WG Adequacy #31

14/06/2024

Public consultation on the scenarios, sensitivities and data for the CRM parameter calculation for the Y-1 Auction for Delivery Period 2026-2027, the Y-2 auction with Delivery Period 2027-28 and the Y-4 Auction for Delivery Period 2028-2029

Storage (1/3)

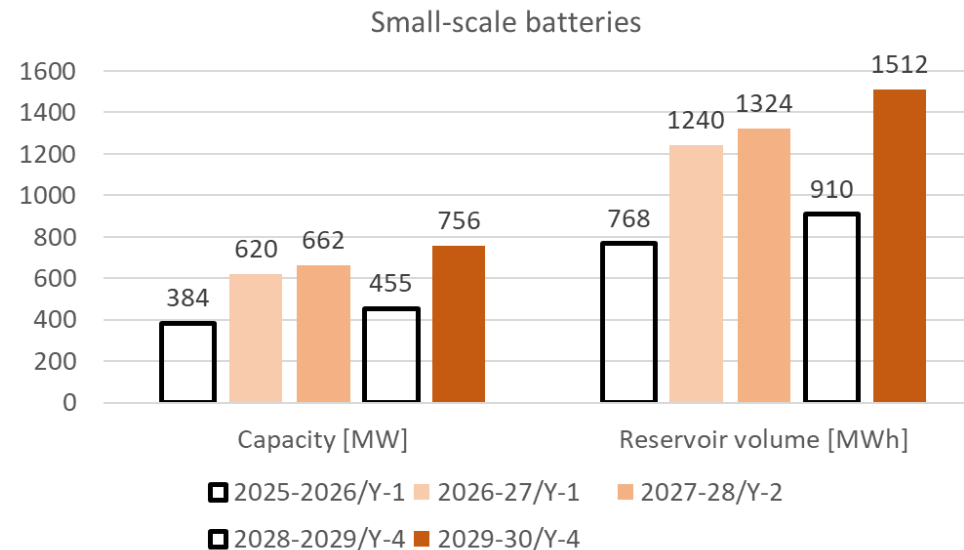
- **CREG** notes that the values given for installed capacity for large-scale and small-scale batteries differ from those given in the Excel table and in figures 4 and 5. CREG considers that the correct values are those given in the Excel table and in figures 4 and 5.
- Elia confirms that the interpretation of the CREG is correct. The Table 1 was incorrect. The capacity of small-scale batteries published in the assumptions workbook excel was incorrect. The correct capacity of small-scale batteries was correct in the slides presented in the WG Adequacy.

Data for other countries (2/3)

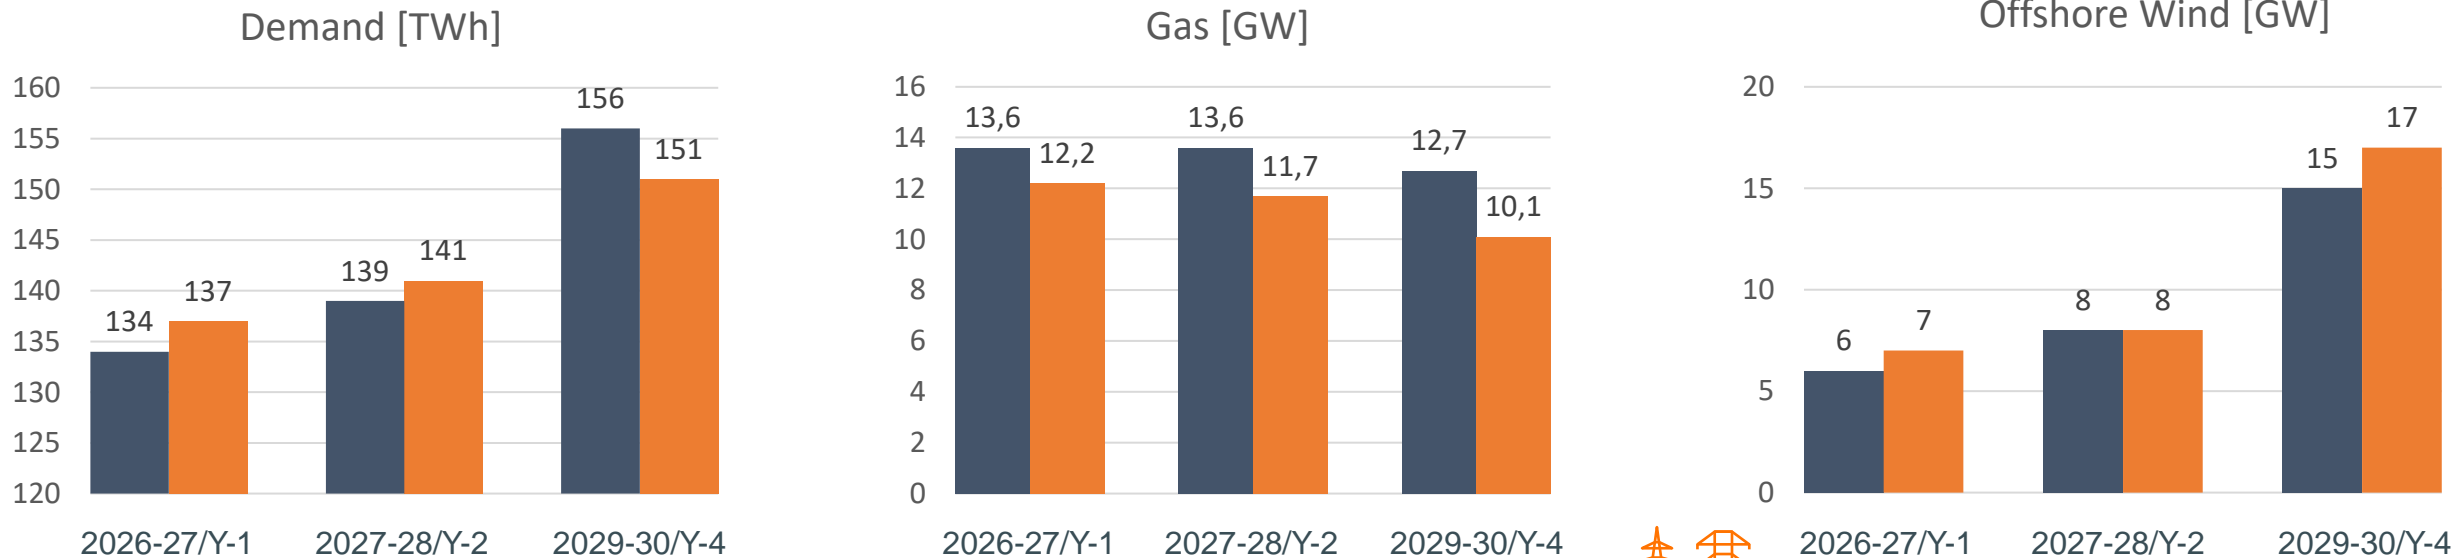
- **SPF** asks for more information about the coal unit Emile Huchet.
- **Febeliec** mentions that it is not clear the cut-off point is taken by Elia to include or not updates or new ambitions.

- Regarding the SPF's comment on the Emile Huchet coal-fired power plant, the plant's conversion project still appears to be vague. Consequently, Elia recommends considering the Cordemais unit as available, but does not recommend considering the Emile Huchet coal-fired power plant as available.
- Elia tries to include in its studies as much as possible up-to-date information. Ideally, the required information is gathered from national studies. Unfortunately, recent official publications for every scenario aspect for every country are not available, especially in the current fast changing context. Therefore, Elia also uses press articles in order to create the most relevant datasets for other countries.
